MOTOR COACH
INDUSTRIES

SUBJECT: SAFETY RECALL OF IDLER PULLEY COVERS
Ref.: **NHTSA # 11V-016**
MCI Service Bulletin 351

Service Bulletin No. 351

MODEL D Series Coaches	TYPE Field Change Program	SECTION/GROUP 6-Cooling	DATE Feb. 8, 2011
SUBJECT MISSING WELDS ON FAN BELT IDLER PULLEY COVER			
CONDITIONS

Figure 2.

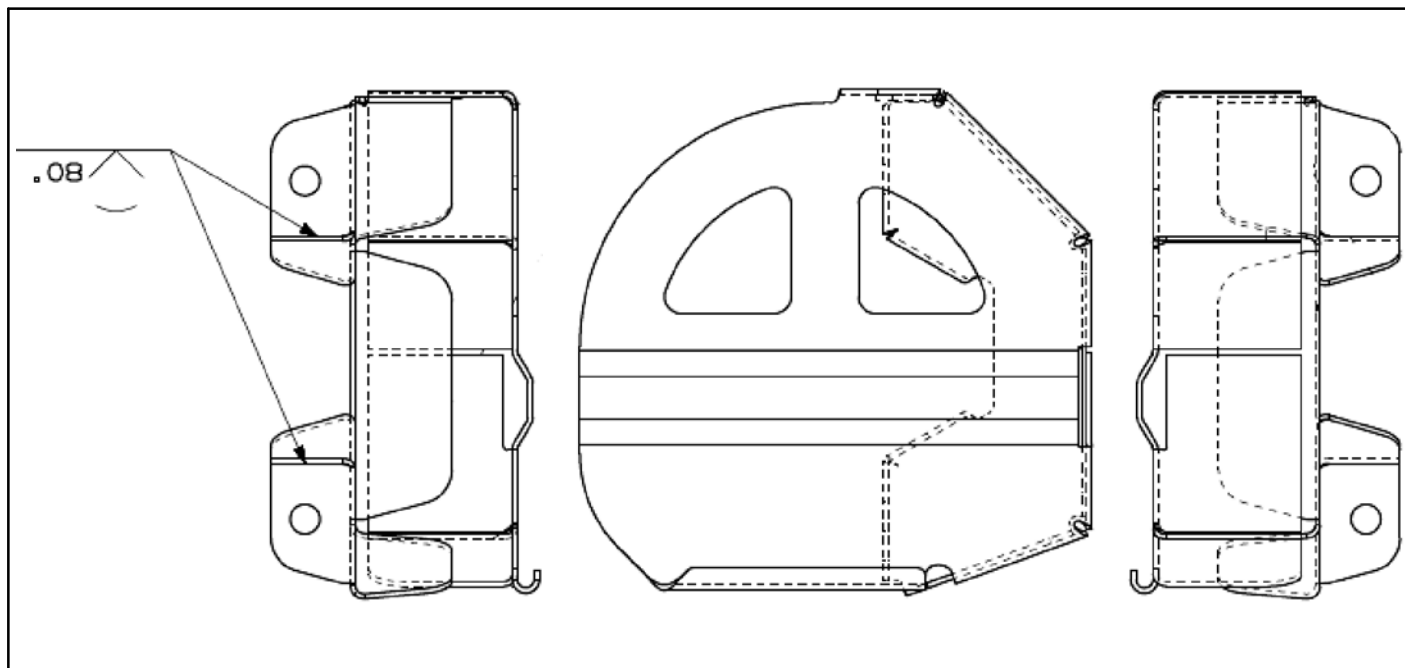
MCI has determined that the fan belt idler pulley cover may lack two welds that provide stiffness and rigidity to the part. Without these welds MCI believes that the part will eventually fail as a result of fatigue near the area where the cover is assembled to the coach structure. If a failure of both attachment areas occurs, the part may become detached from the coach and potential injury to persons and/or damage to other vehicles or property could occur.

4. Visually inspect the fan belt idler pulley cover for the two (2) welds shown in Figure 2

If the two (2) welds shown in Figure 2 are on the fan belt idler pulley cover, no further action is required. Close the engine door. Fill out the attached verification form and submit to MCI's warranty department.

If the two (2) welds shown in Figure 2 are not on the fan belt idler pulley cover, proceed to Step 5.

Figure 3.

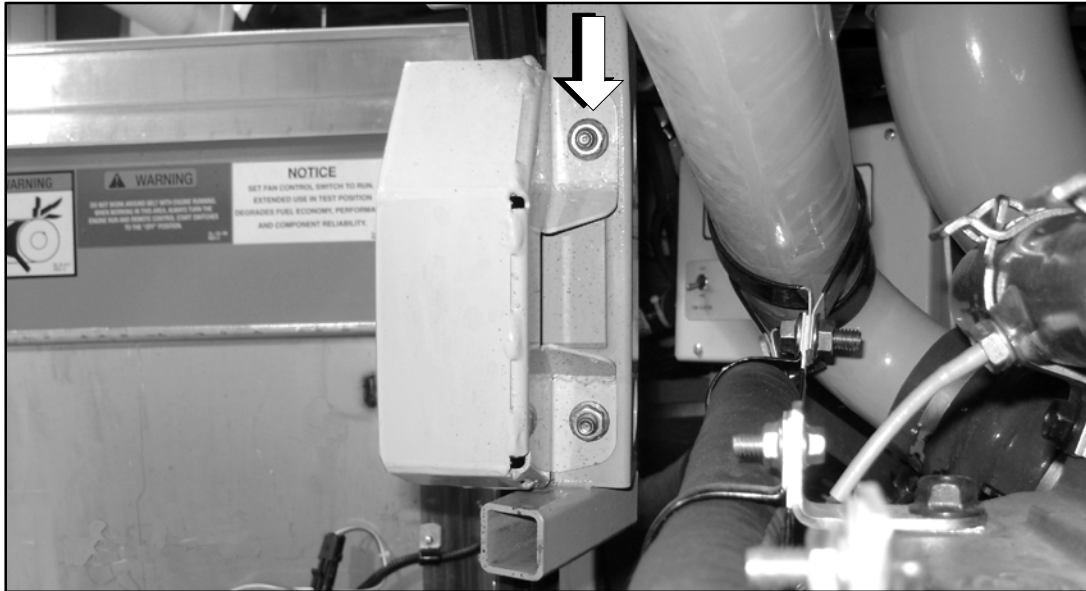
5. Remove and retain the idler pulley cover mounting hardware (refer to Figure 3). Discard the existing idler pulley cover.
6. Using the existing mounting hardware, install the new idler pulley cover, p/n 06-06-1629.
7. Torque to 43–47 ft.-lbs. Apply torque seal from the face of the capscrew to the face of the cover.
